SUNDRY NOTICES AND REPORTS ON WELLS

8. Well Name and No.
Getty 24 Federal #13 /

9. API Well No.
30-015-31801 /

RE: Plugging and Abandonment Requirements, Conditions of Approval

Current Wellbore Diagram**Well ID Info:**

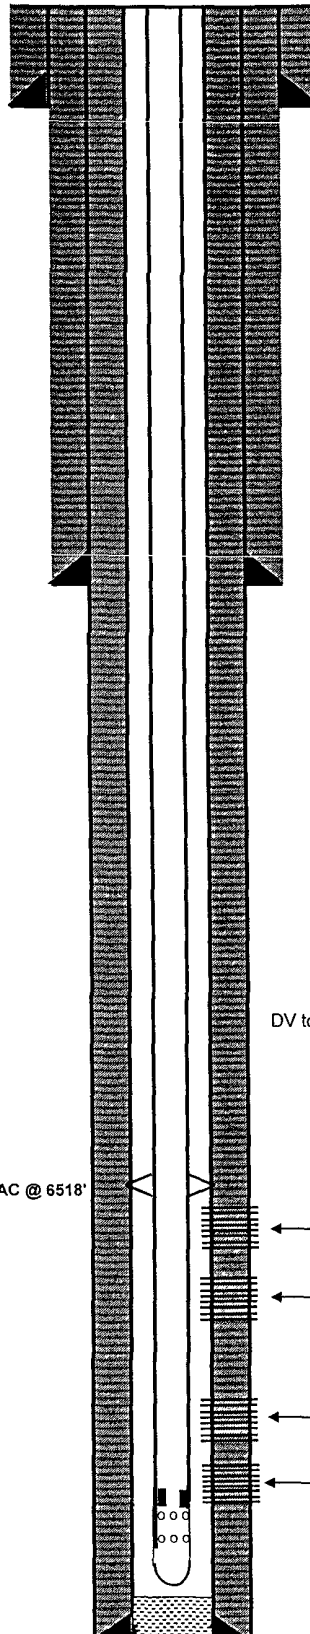
1. Notify BLM 24 hrs prior to MI and RU.
2. RIH set CIBP at 6500', spot 70sx plug of class "H" cement from 6500'-5950' (perfs/DV tool).
3. Displace hole w/MLF, 9.5# Brine w/25# gel P/BBL.
4. Perf 4 holes at 4614', sqz 80sx cement from 4614'-4297' (shoe/B.salt).
5. Perf 4 holes at 983', sqz 75sx, plug from 983'-690' (shoe/T-Salt) WOC Tag.
6. Perf 4 holes at 400', sqz 100sx, plug from 400'-surface (Fr.Wtr./surface) WOC Tag.
7. Install dry hole marker.

1. OK
2. WOC and tag at 6045' or shallower – Otherwise OK (Perfs – DV Tool)
3. OK
4. WOC and tag at 4345' or shallower. If injection rate cannot be established, spot cement 50' below perfs – Otherwise OK (Delaware – BOS – Casing shoe)
- 4a. Perf and squeeze a plug from 3725'-3585'. WOC and tag at 3585' or shallower. If injection rate cannot be established, spot cement 50' below perfs. (DV Tool)
5. Tag at 740' or shallower. If injection rate cannot be established, spot cement 50' below perfs – Otherwise OK (TOS – Casing shoe)
6. If injection rate cannot be established, spot cement 50' below perfs – Otherwise OK (Surface)
7. Verify cement to surface in all annuluses. Ground Level Dry Hole Marker required in this area. **Requirements** attached – Otherwise OK
8. Submit a subsequent report to the BLM.
